## Official Question and Answer Document for the 2016 Land Art Generator Initiative Design Competition

The questions below have come directly from LAGI 2016 participants. The answers may provide you with additional insights, links to relevant documents, or spark design ideas. This document should be considered as an addendum to the **LAGI 2016 Design Brief** itself.

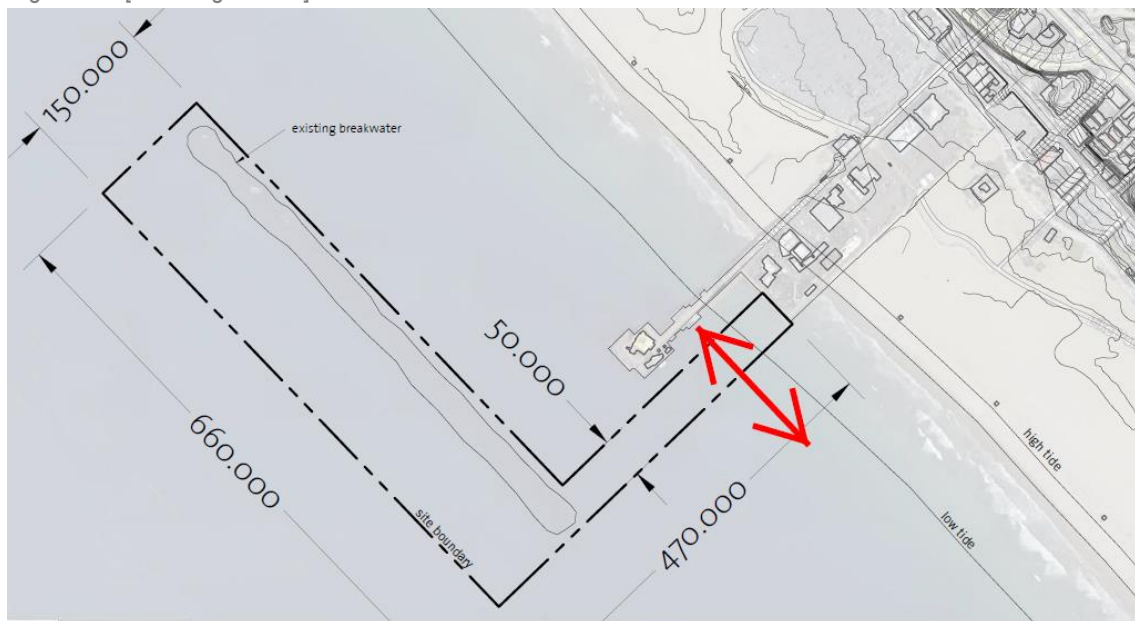
2. Q: Do you have a list of who is entering this year's competition? I am a waste artist and would like to enter the competition. I am seeking an architect, alternative power designer and a marine biologist who might live around the Southern California area.

**A: We have recently re-opened an online social tool called Town Square at <http://landartgenerator.org/townsquare/>. It's designed to allow you to search other participants for their skill-set and form teams. As a social networking engine, it's only as powerful as the number of people that use it.**

**diagrammatic section through the site**

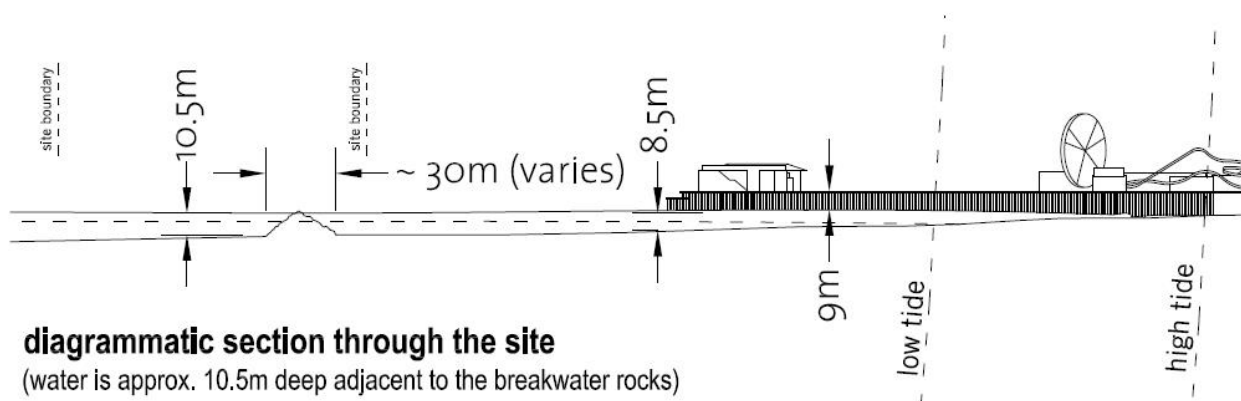
14. Q: What is the height above the ocean floor of the pier?

15. Q: What are the dimensions of the water break, the width, length, and height?

**A: Please see the diagram below which is printed from the LAGI-2016-Design-Site-Boundary-Santa-Monica.dwg file: [[http://landartgenerator.org/designcomp/downloads/LAGI2016-LOCATION\\_PLAN.zip](http://landartgenerator.org/designcomp/downloads/LAGI2016-LOCATION_PLAN.zip)]. As for the overall length of the breakwater, it is not continuous, and the best estimation can be made from looking at the shadows in the satellite imagery, but we guess that it is about 30 meters wide.**

(water is approx. 10.5m deep adjacent to the breakwater rocks)
